PLANNING BOARD MEETING

b. **Project:** Site Plan Review – 164 Auburn Road

Project Description: Site Plan Review of new professional office park and associated site work including new paving and stormwater management practices. This project is located in

S.E.E. Associates is in receipt of your review letter dated August 25, 2025. You provided this letter following a developer's conference which was suggested by the Planning Board at their July 28, 2025, meeting. The developer's conference was held on August 5, 2025, and attended by you, Dean Shea – Planning Board Chairman, Eric Eisenhut – S.E.E. Associates, and myself. I have included the items from your review letter below as *italicized text* and have provided our responses in **bold** text.

DRAWING NUMBER C-106

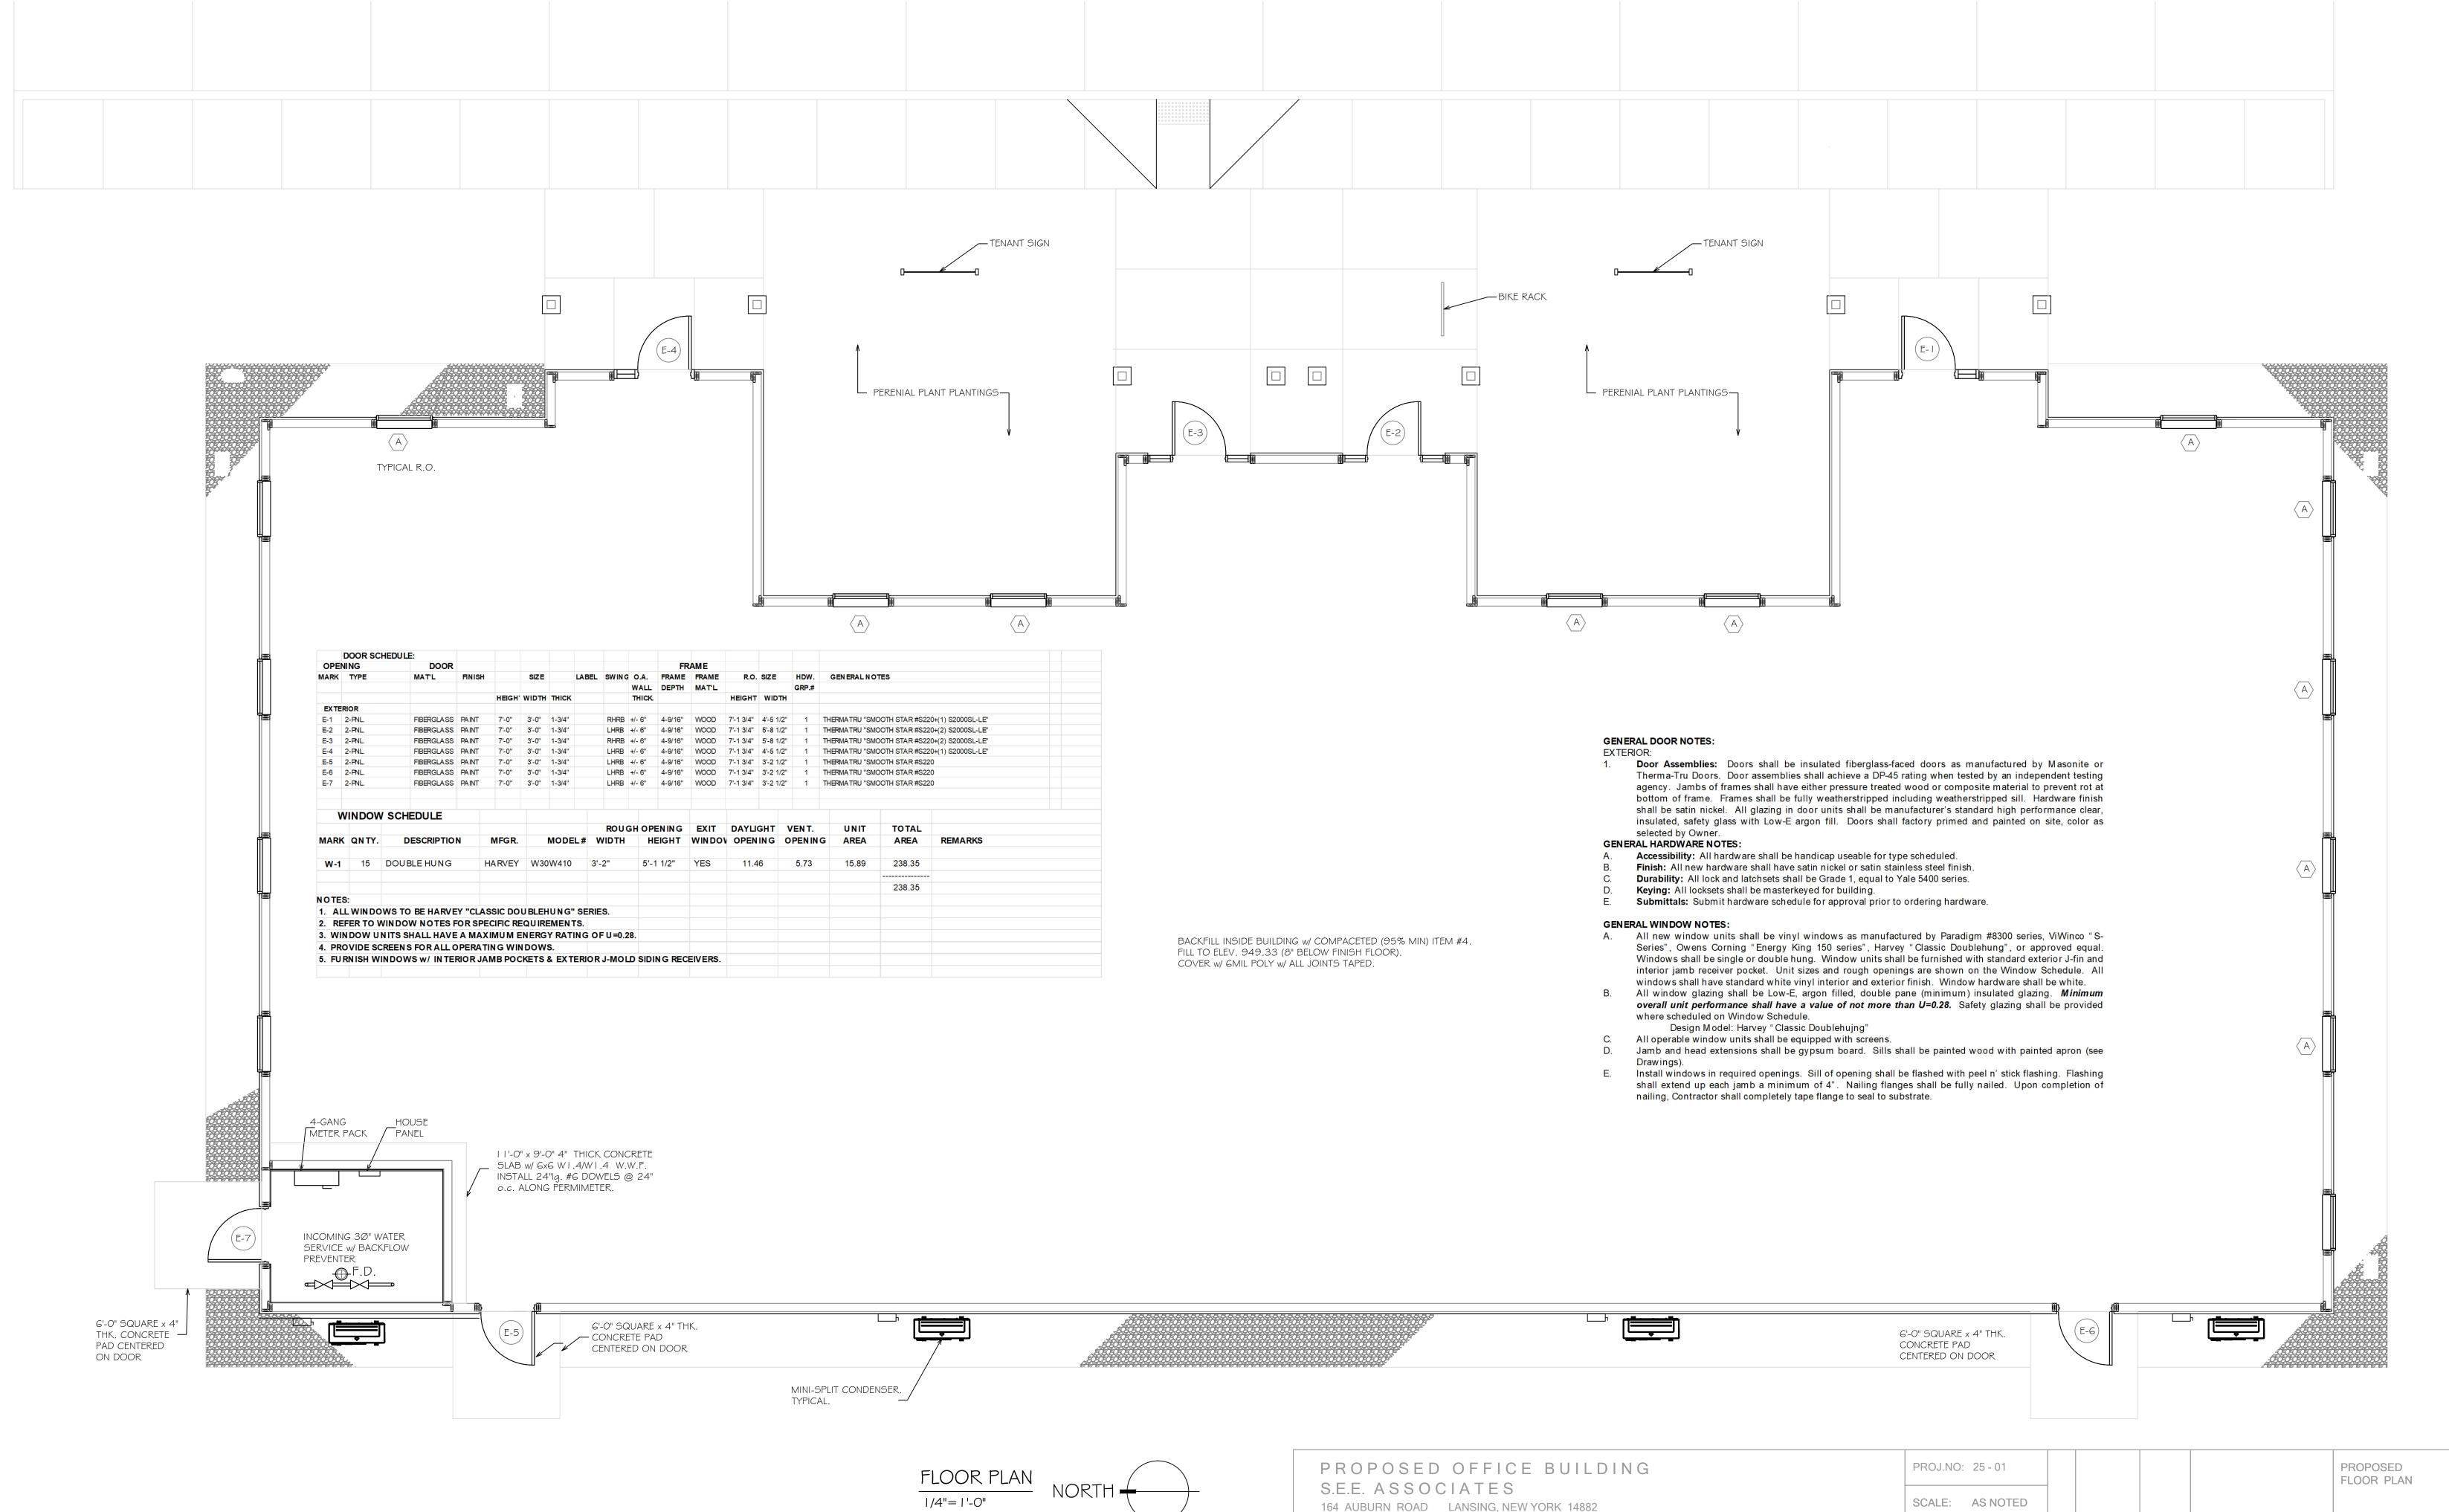
- Please provide a landscaping plan per the site plan application checklist, § 270-40.1 and §270-27 H.
 (9). of the zoning code. Additional guidance can be found in §270 attachment 8 "Town of Lansing Buffer Chart".

- Proposed plantings and a plant schedule were included on drawing C-103 "Site Plan and Details" as part of the original submission dated May 27, 2025. At the June 23, 2025, meeting the Planning Board requested additional plantings be added along the north property line to screen the parking lot from the neighbors to the north. They also requested low shrubs be

added to the berm located east of the parking lot. Drawing C-106 "Planting Plan and Details" has been added to the drawing set showing the additional plantings.

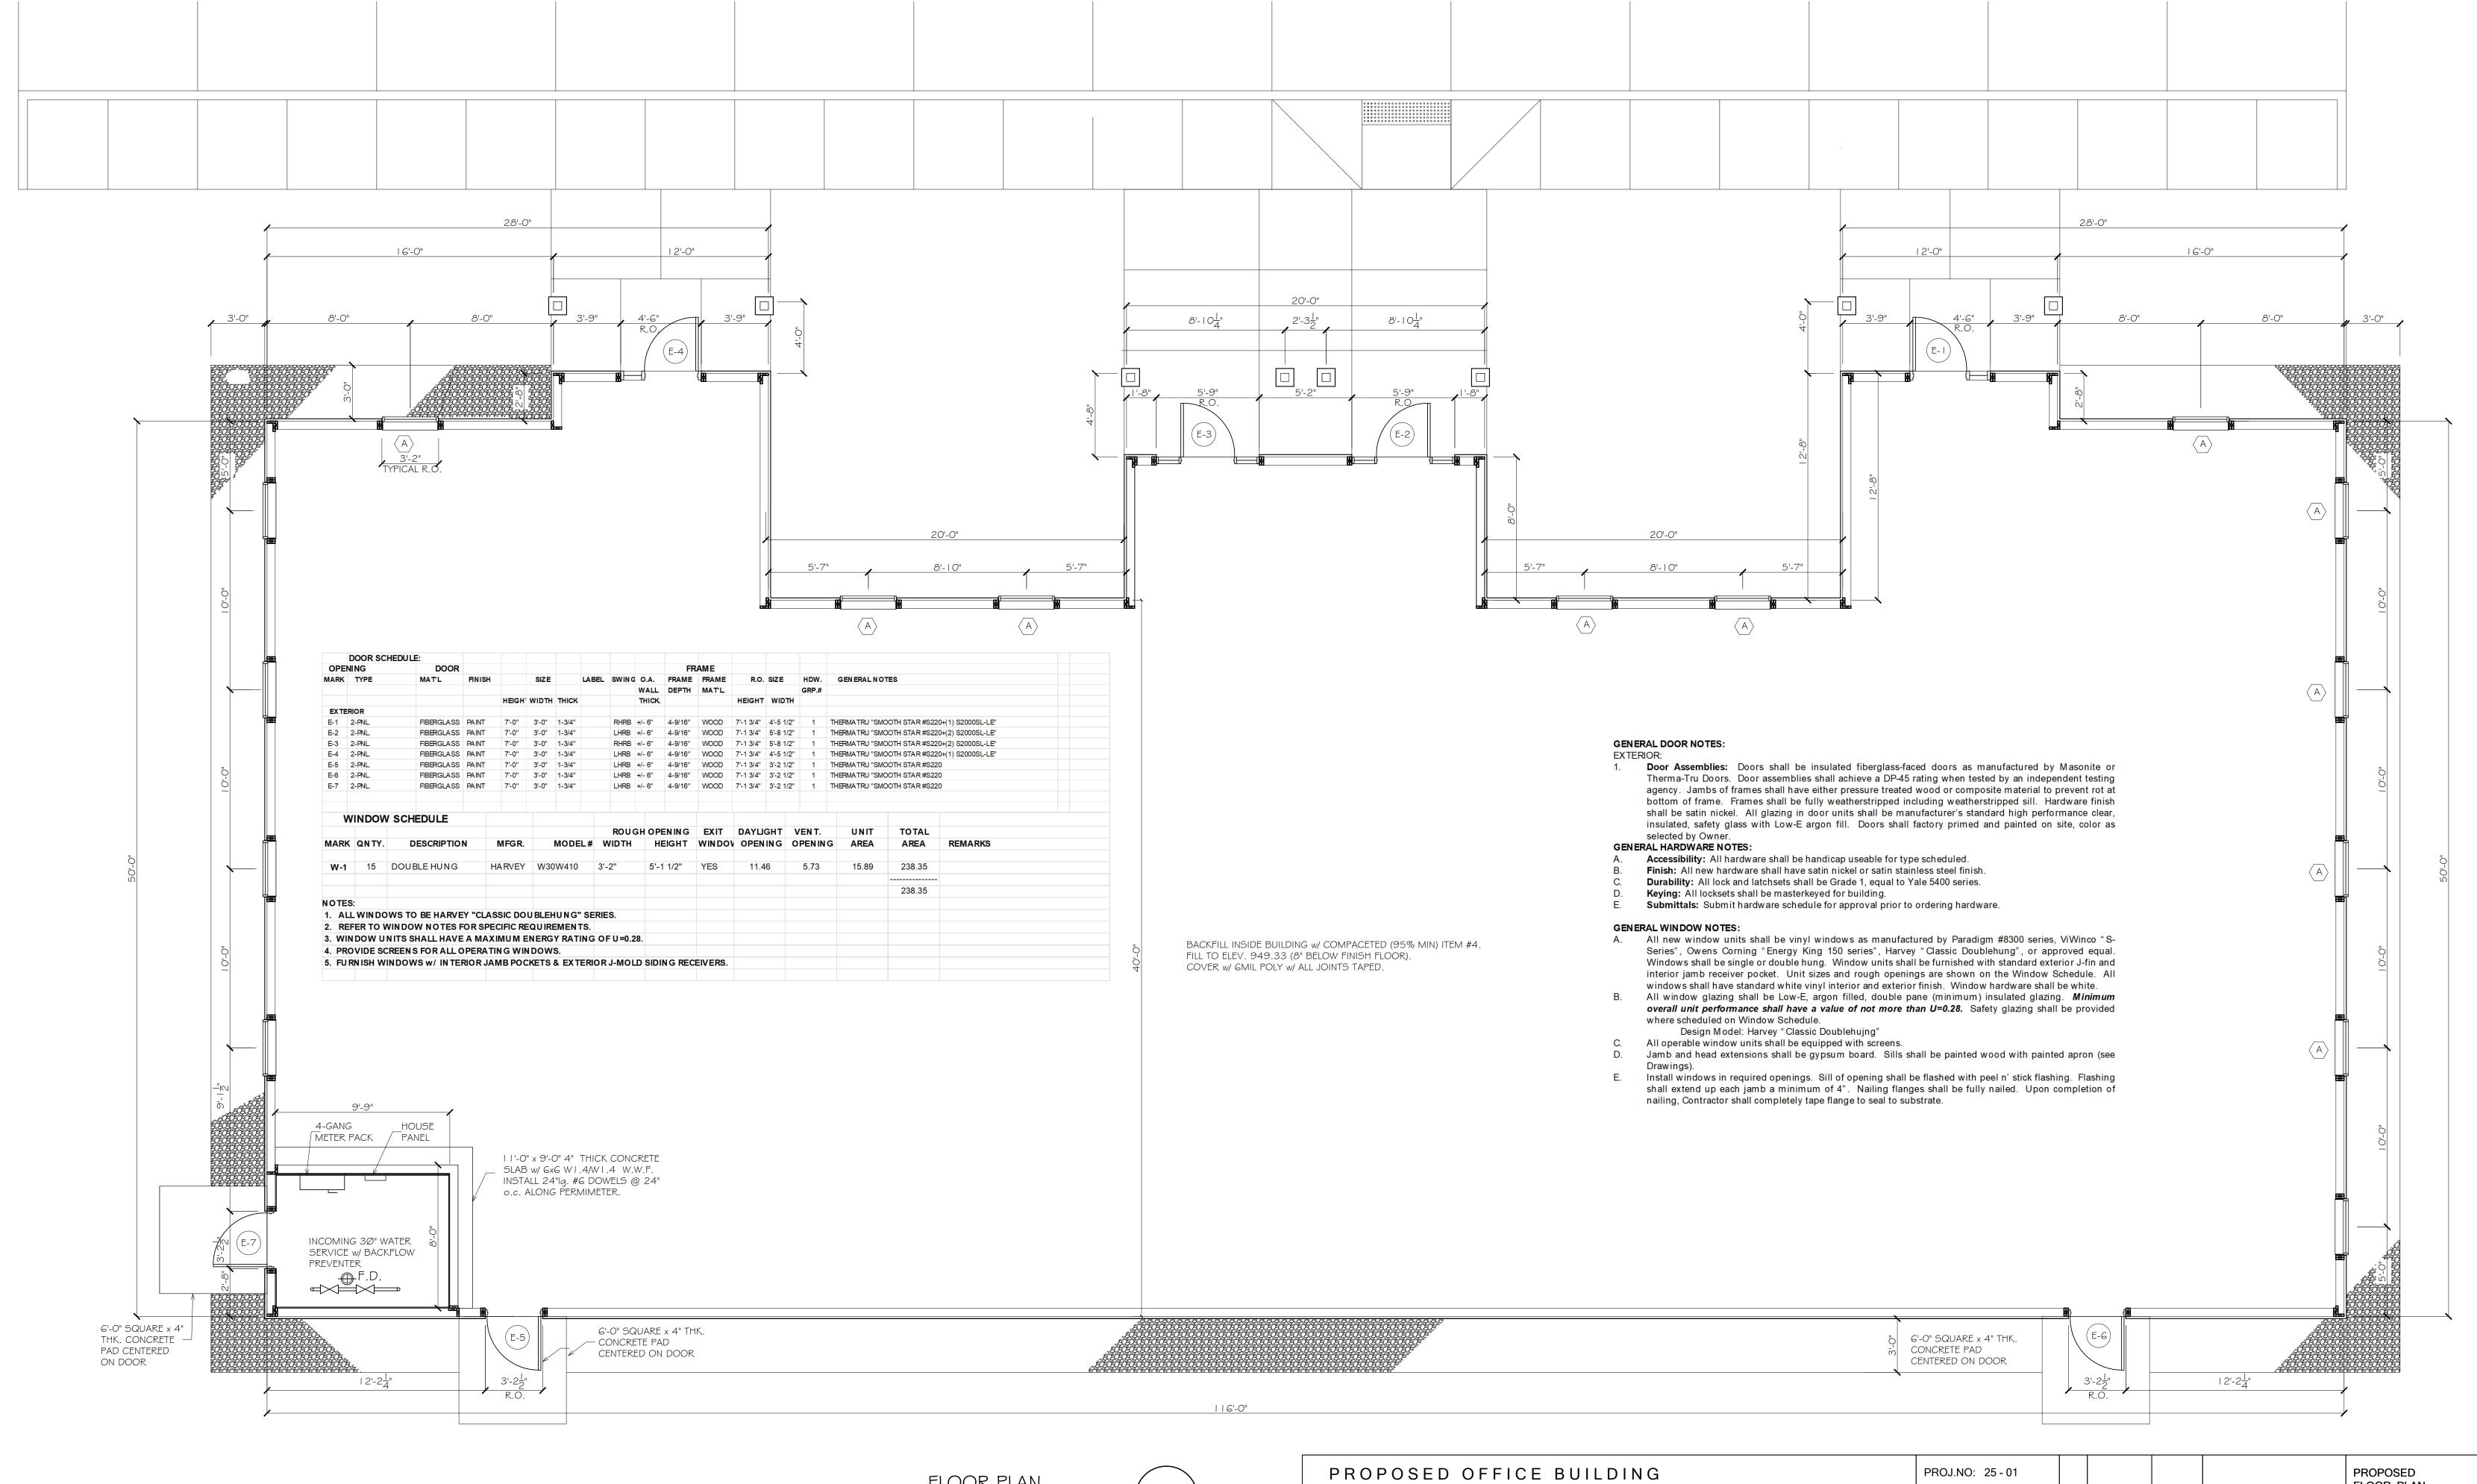
- 8. Please show the method by which solid waste receptacles will be screened §270-27 H (15). Due to the small size of the building, exterior dumpsters will not be necessary. Tenants will use individual toters for trash and recycling that will be stored indoors, then rolled out to the parking lot on pickup days. A 7' x 18' paved area for these toters has been located at the north end of the parking lot and screening plantings have been shown.
- Please show the location building mechanicals and provide adequate screening. §270-27 H (16) & (17).

Mini-split condensers will be used for heating and cooling and will be located in the rear of the building out of view of the general public as shown on drawing A-1 "Proposed Floor Plan". No screening is proposed.
